RESPONSE TO U S EPA COMMENTS ON SITE INSPECTION REPORT FOR MUNITIONS
RESPONSE PROGRAM RANGES WITH REPLACEMENT PAGES AND ADDENDUM TO
VOLUME II WITH TRANSMITTAL NSTC GREAT LAKES IL
12/1/2010
TETRA TECH

Subject: Site Inspection Report for Munitions Response Program Ranges
Response to Illinois EPA Comments

Navy Response to Comments received from Brian Conrath, IEPA on Volume I and II of the Site Inspection Report for Naval Station Great Lakes, November 12, 2010.

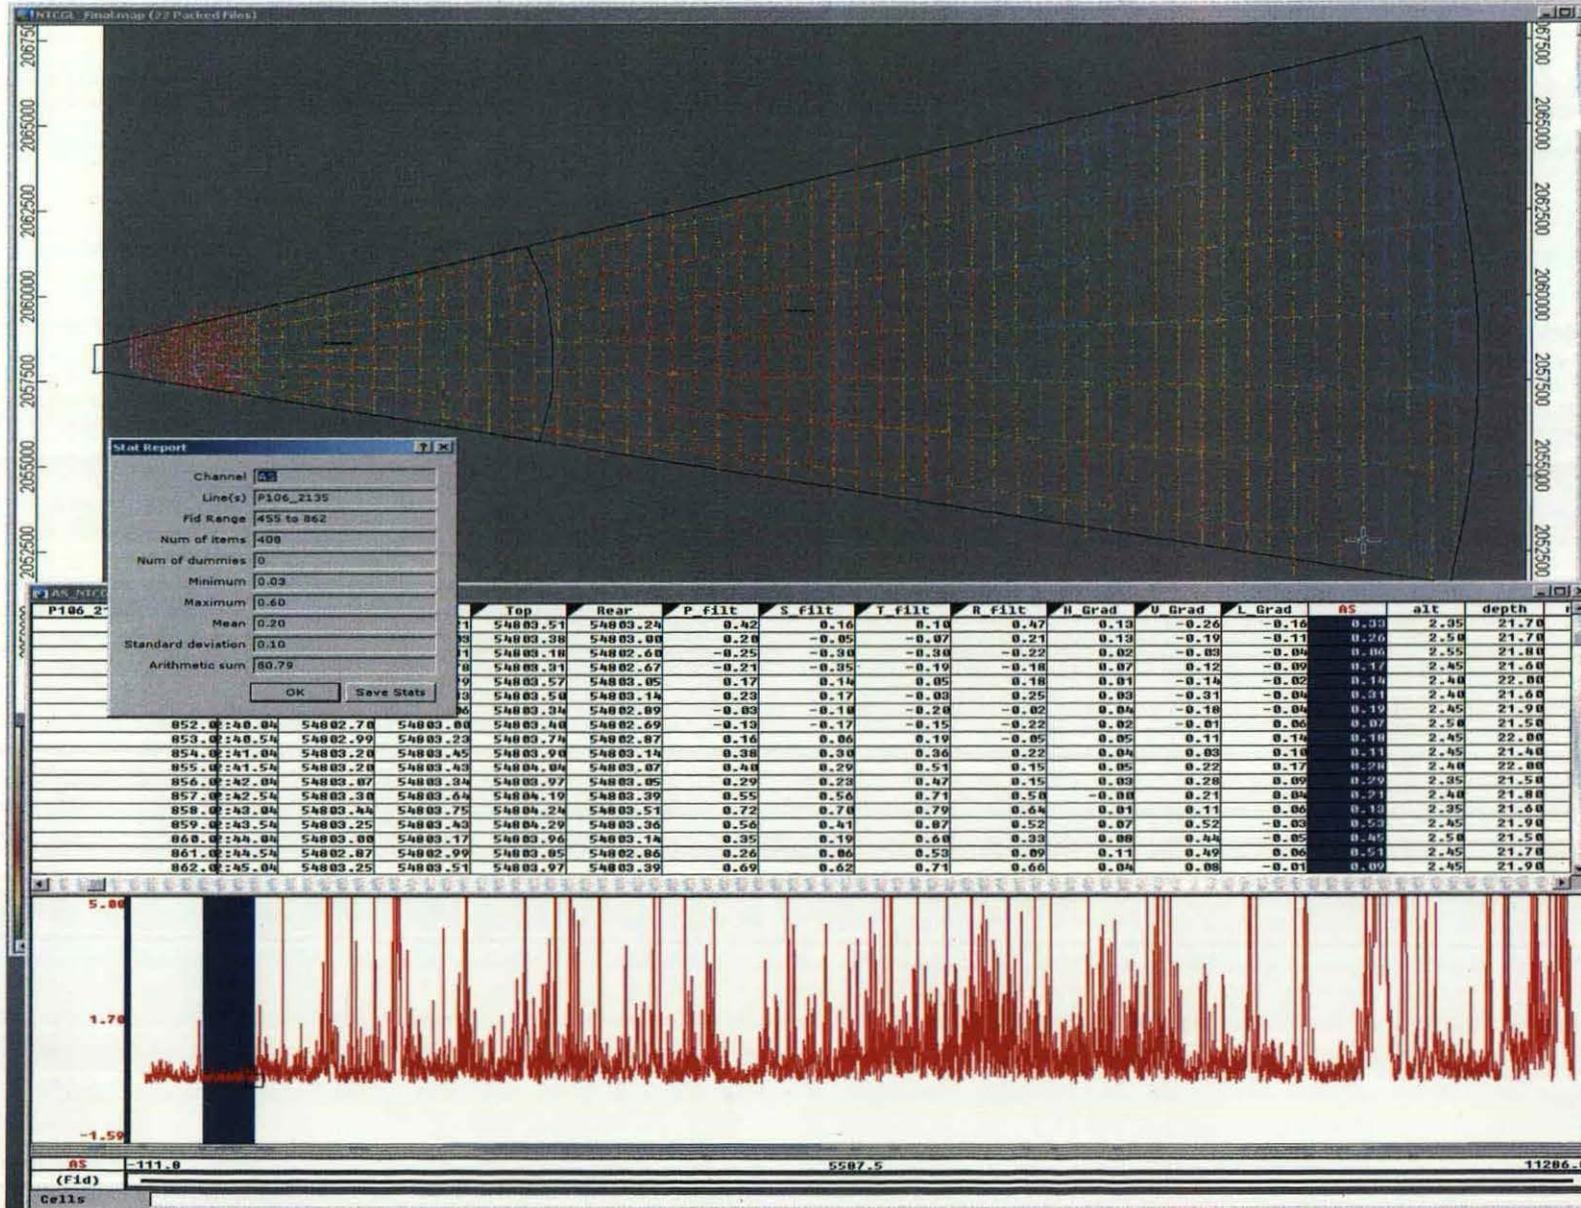
E-mail Comment #2: Secondly, if the IVS strip could not be used as intended and there was no way to effectively test the MGA to ensure it would detect the munitions items expected to be in the area being investigated, what assurance is there that it was working properly or that the munitions of interest would be detectable?

Response: The IVS and daily QC tests confirmed positional accuracy, equipment functionality, repeatability of results, and the feasibility of detecting metallic objects in the harbor. (refer to response to comment #1). As for the detectability of munitions items expected to be in the investigation area, the expected responses for single 40mm and 20mm items are highly dependent on the system noise levels, as the documented magnetic anomaly amplitudes can be less than 1nT for single items. The IVS was not used for system noise measurement. Areas within the project area with low concentrations of anomalies were used to document that the system noise levels were below 1nT (see statistics dialog boxes below, the analytic signal (AS) mean plus two times the standard deviation is not above 1nT).
